SAN LUIS OBISPO COUNTY
DEPARTMENT OF PLANNING AND BUILDING

SUBJECT: APPEAL OF DRC2008-00103 – COUNTY OF SLO - LOWWP
HEARING DATE: August 13, 2009 / PLANNING COMMISSION

(LOS OSOS WASTEWATER PROJECT)

Planning Commission Protest LOWWP

Figure 8.4 Typical Septic Tank Locations – Retrofit & New

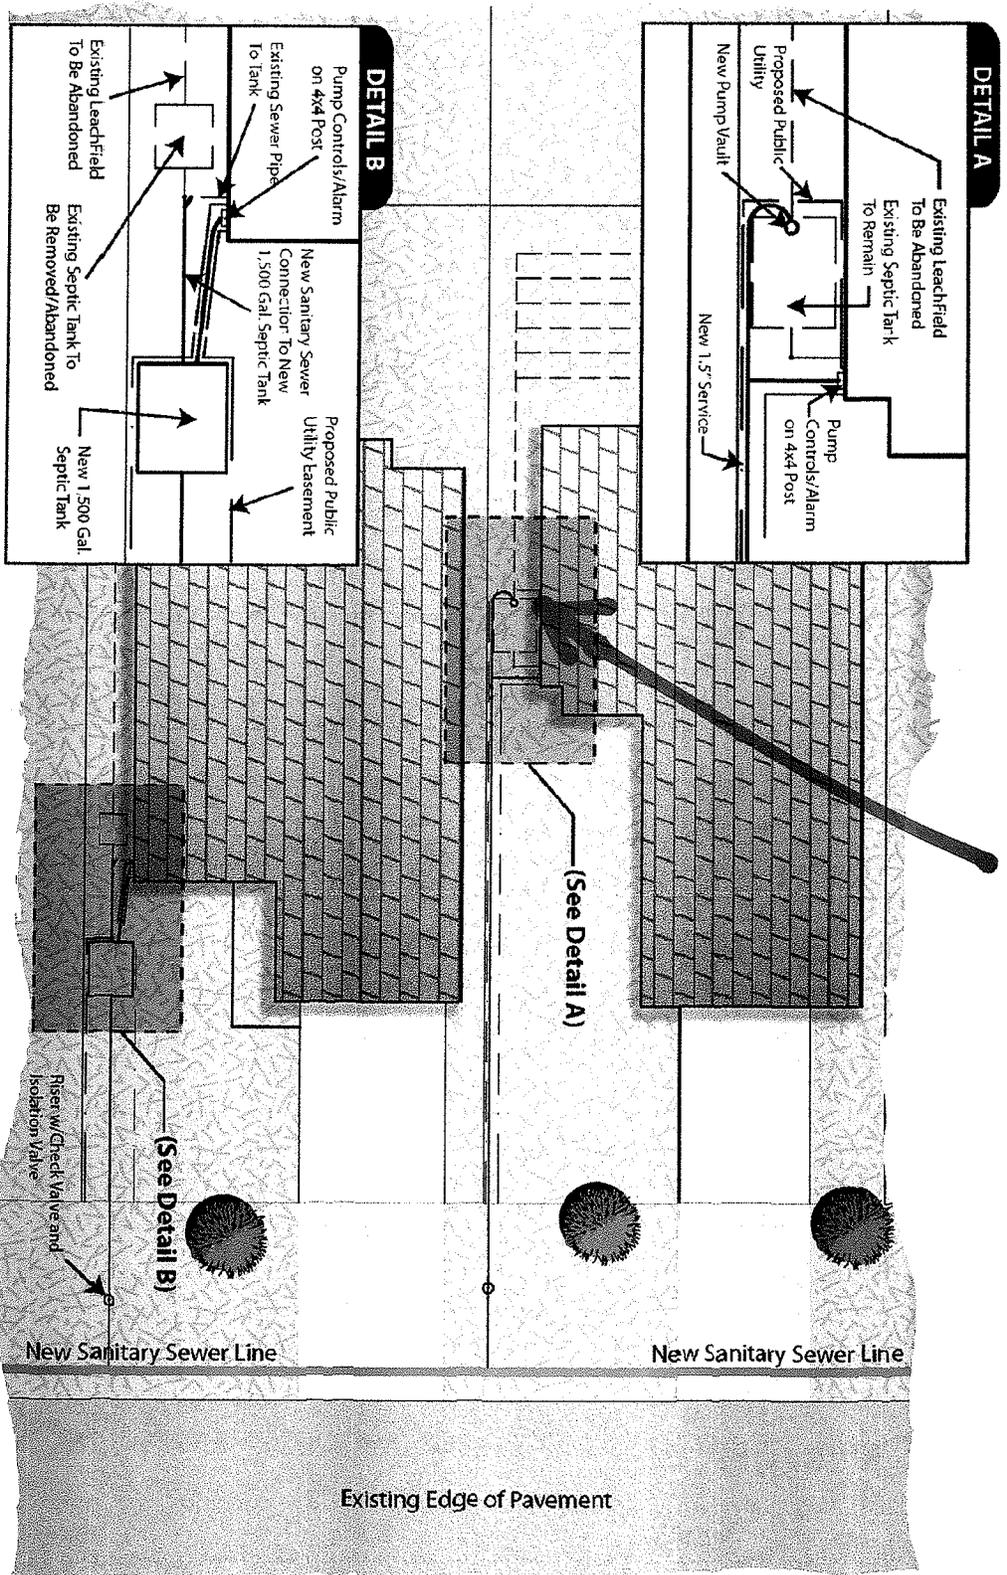
SHOWS USE OF EXISTING SEPTIC TANK.
